GARBRICK MANUFACTURING, INC.

Due to the age of the Ground-model Merry Mixers, it is recommended that Non-destructive Testing be performed as a safety precaution on the spindles which hold the seats.

ILLINOIS DEPARTMENT OF LABOR

I received your letter of July 3rd recommending a nondestructive test on the Merry Mixer seat spindles. I have several questions regarding the recommendation.

SECTION A-A
Scale: 2" = 1'-0"

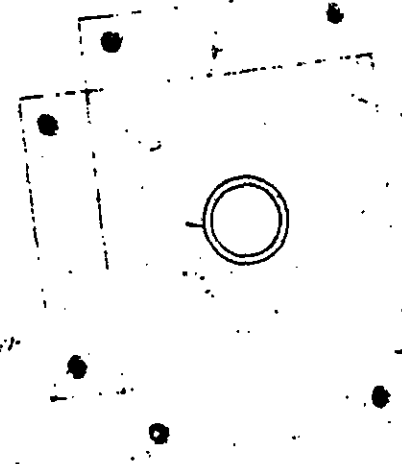
At what frequency is the test to be performed? Is it to be performed only once, is it to be performed annually, or is it to be done at some other interval time?

What is the recommended test method: ultrasonic, magnetic particle, x-ray or other?

Also, the print provided does not reproduce well. Is it possible to get a legible sketch/drawing for the NDT technician to work from?
